ENGINE - H.P. COMPRESSOR - TO ANNOUNCE NEW H.P. COMPRESSOR STAGE 9 TO 12 DISCS -
CATEGORY CODE 7 - MOD.ENG-72-0102

V2500-ENG-72-0102

Location of stage 9 to 12 compressor discs
Fig.1

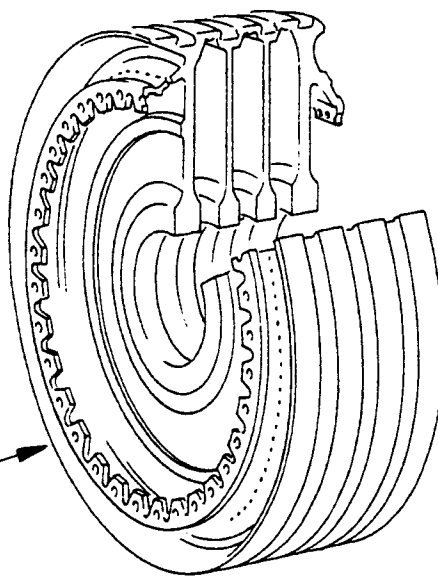
- (a) A new H.P. compressor stage 9 to 12 disc assembly which is identical to the existing assembly except for manufacture source.
- (b) For effect on declared life refer to Engine Manual, 5-10-1 Group 'A' part lives.

REMOVE 2A3200 DISC AND
INSTALL 6A4131 DISC

- (1) New 6A4131 disc, stage 9 to 12 H.P. compressor is interchangeable with in use disc, stage 9 to 12 H.P. compressor.
- (2) Assemble new 6A4131 disc, stage 9 to 12 H.P. compressor by use of approved procedures, Engine Manual 72-41-10, Assembly.
